16 September 2025

Thank you for your letter, dated 2 September 2025, regarding the Haldon Solar application from Lodestone Energy Limited (Lodestone / the Applicant).

Please find below the response from the Canterbury Regional Council on considerations of the completeness of the Applicant's Substantive Application under the Fast-track Approvals Act 2024 (the Act / FTAA).

Map 1: The proposed solar farm footprint and layout as presented by Figure 3 of the Ecology Report (Page 7). Lower image shows solar array layout in greater detail illustrating gaps between panels which may mitigate the risk of bird strike.

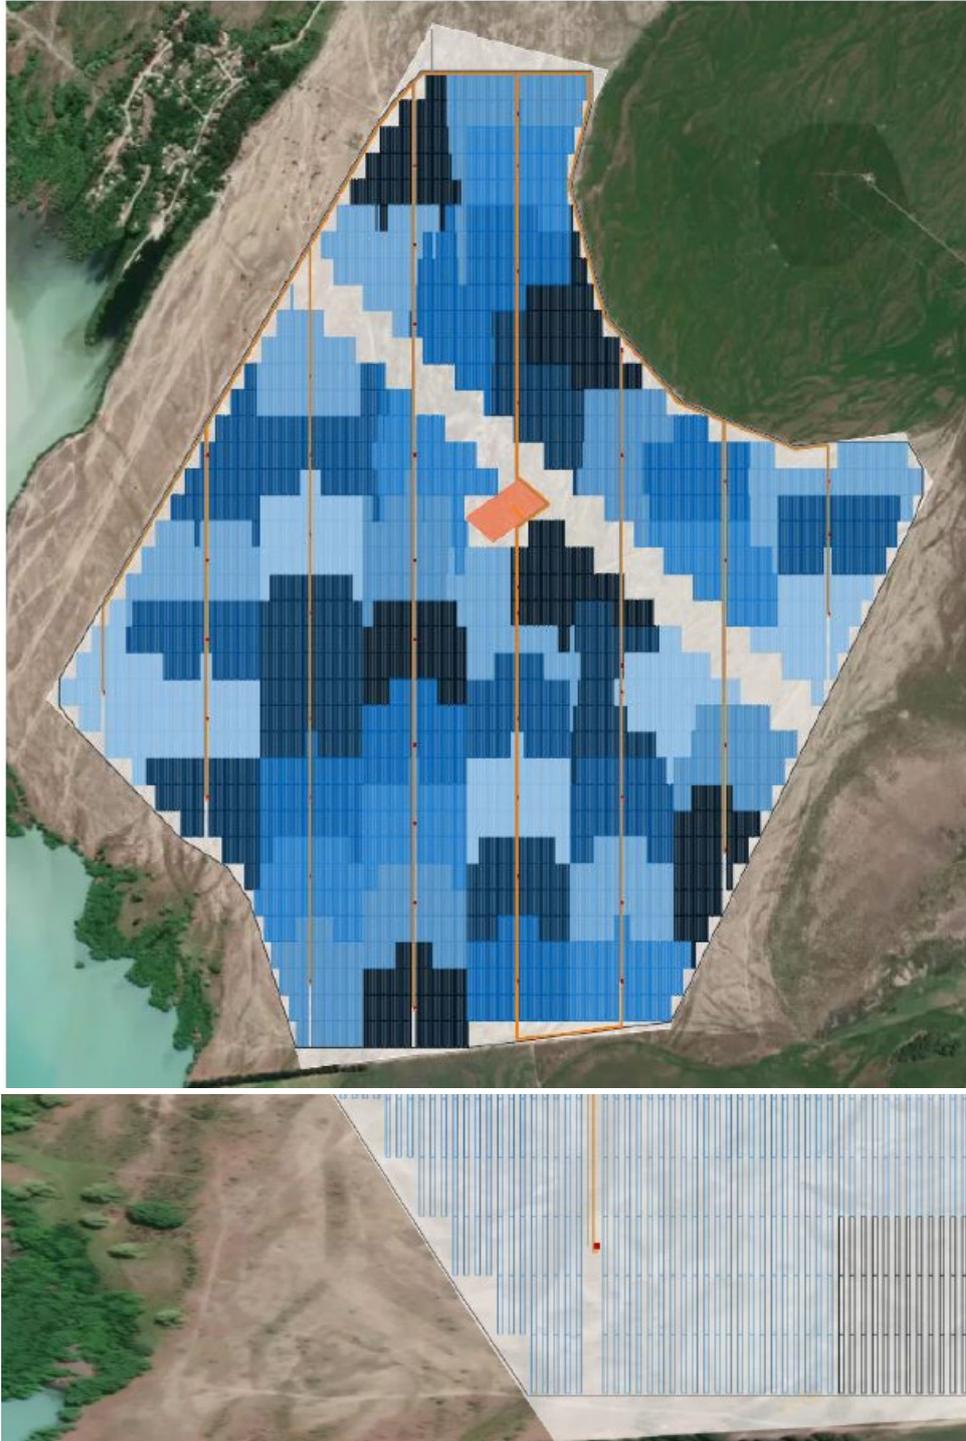
- Construction of perimeter deer fencing at a height of approximately 2.0 m, including a rabbit fence along the lower portion, is proposed.
2. The proposed solar farm will alter environmental conditions of 320ha of ecologically significant dryland habitat. These changes will favour exotic plant species and exclude / reduce the abundance of native dryland species. This will result in unavoidable residual effects for which compensation and offsets would be required.

- II. Changes to soil moisture gradients; shading and stormwater management will transform environmental conditions of 320ha of ecologically significant dryland habitat. These changes will favour exotic plant species and exclude / reduce abundance of native dryland vegetation and, potentially, the associated fauna.

61. There are no known easy fixes for bird strike risk, however several mitigations have been suggested including solar array spacing (as proposed by the Application³¹), positioning of panels at night, anti-reflective coatings, minimization of night lighting and, importantly, monitoring and adaptive management. Although the feasibility of adaptive management once a solar farm is established, particularly if the mitigation provisions noted above are already adopted as would be recommended here, is questionable.

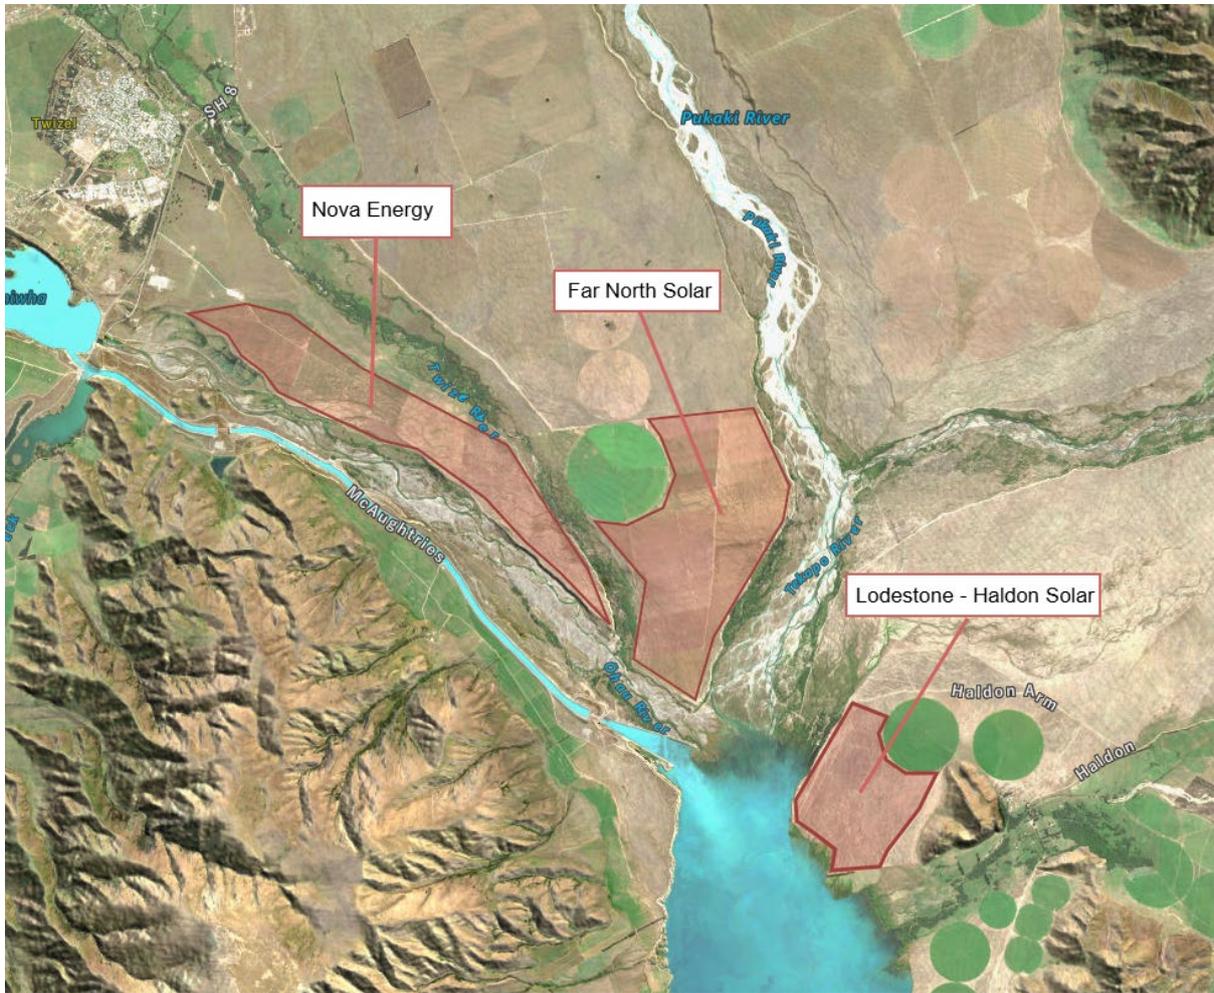
53. If present within the wider area, these wetland habitats adjacent to Lake Benmore would not be considered natural inland wetlands under the National Policy Statement for Freshwater 2020 as they have been induced by the constructed waterbody of the lake. However, they may provide habitat to indigenous fauna and thereby warrant consideration for potential effects of the proposal (see below fauna considerations).

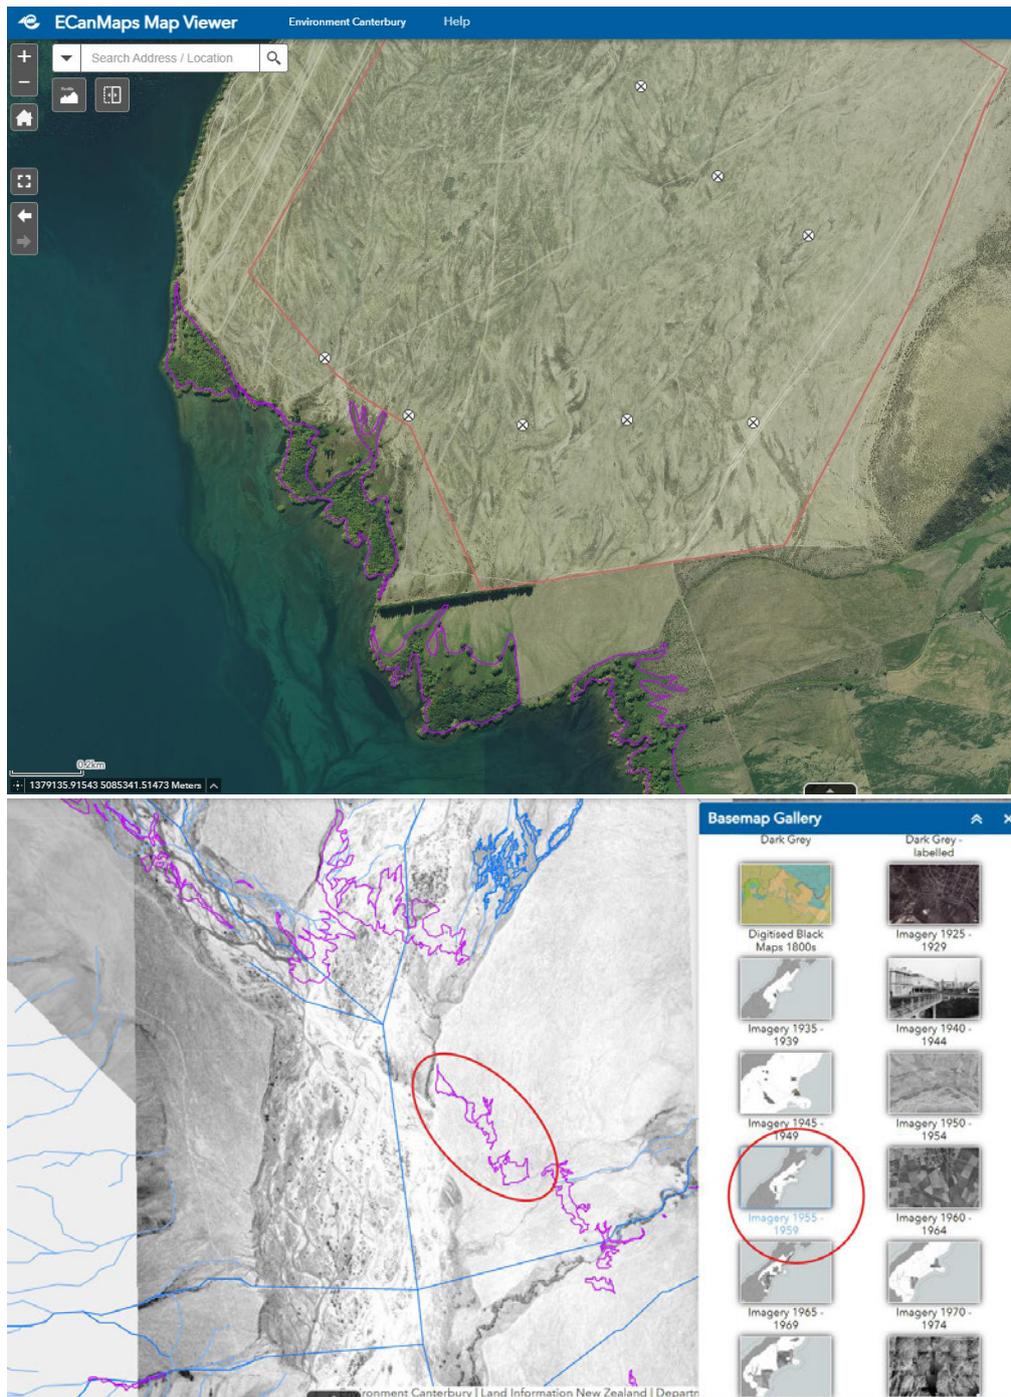
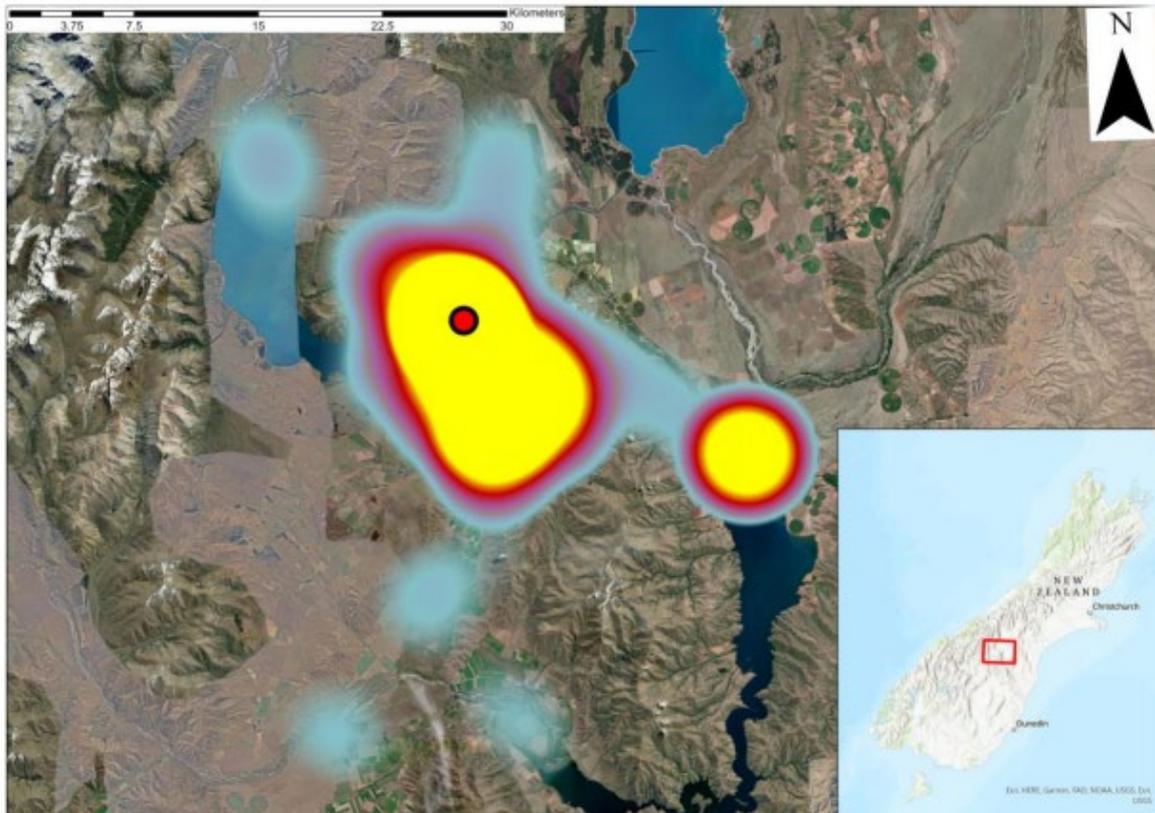
56. The site is located at a hot spot for Nationally Threatened and At-Risk bird species which frequent the Ohau-Tekapo river delta at Lake Benmore. Flight paths of these birds are known to traverse directly across the proposed solar farm site. This is known in detail for at least one species – black fronted tern - from recent research which placed transmitters on birds' flight revealing their flight routes²⁹ (see **Attachment 4**).

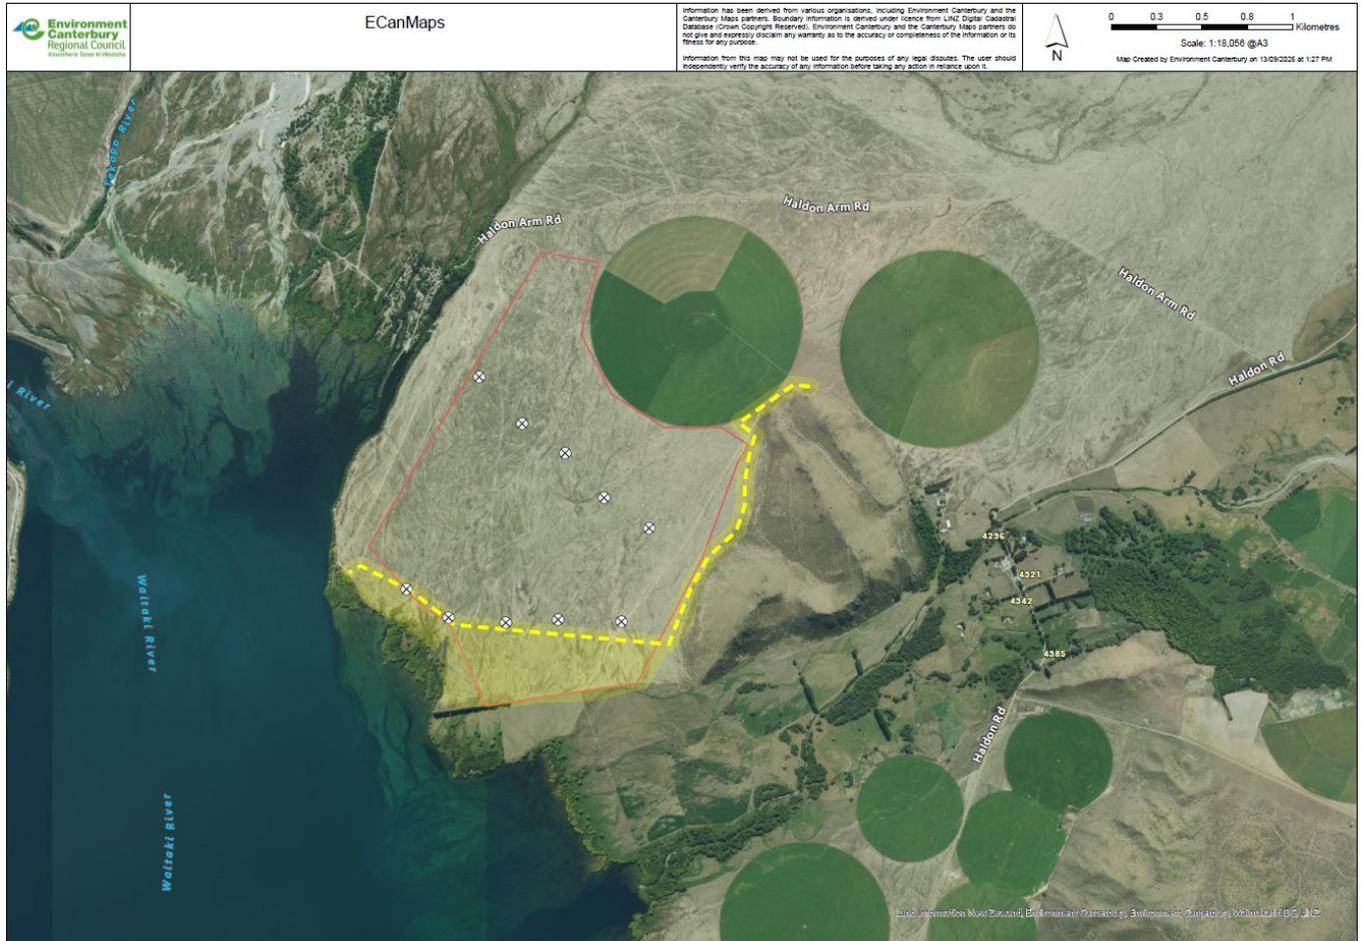
71. Potential effects on lizards primarily relate to injury, death and disturbance from construction activities, while solar arrays may reduce habitat quality due to shading and habitat fragmentation.
72. The proposal may also enhance lizard habitat, as the vegetation cover predicted to increase with the establishment of the solar array and fencing could add to habitat complexity.
73. I recommend that further consideration of habitat and surveys occur to inform the assessment of effects, or that potentially suitable habitat is identified and avoided/considered. Perimeter fencing design might also consider any benefits to the inclusion of habitat areas for lizards.
74. Appropriate survey methodology would require a permit to be attained under the Wildlife Act 1953 from the Department of Conservation to catch and handle lizards or disturb their habitat.
